Date 22.03.02	Ref. No. TV01602	Model KV-29FX66E, KV-29FX66K, KV-29LS60B, KV-29LS60E, KV-29LS60K	BC
Subject East-West Distortion			IRIS 1335

SYMPTOM

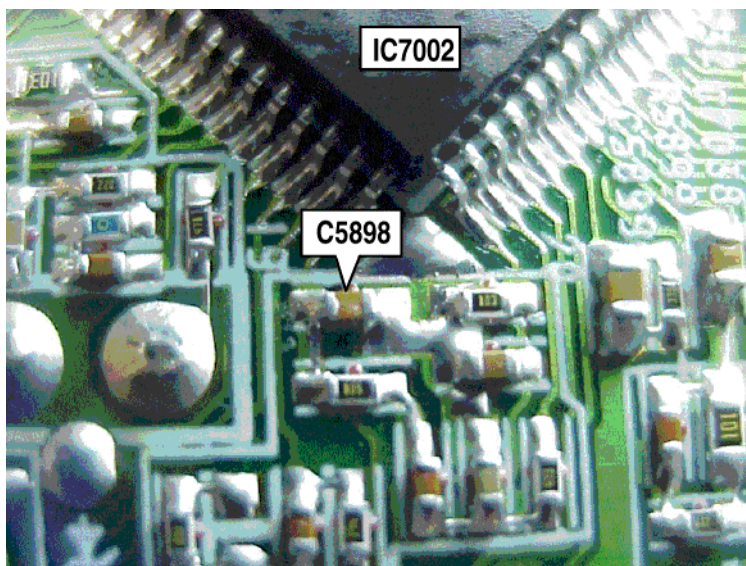
East-west distortion.

Q8803 on the D Board becomes defective after several hours of operation due to a breakdown of C5898 on the A Board.

Replace C5898 "Ceramic Chip 0.001 μ F 10% 50V" (1-162-964-11) and Q8803 "2SC5698-CA" (8-729-056-16).
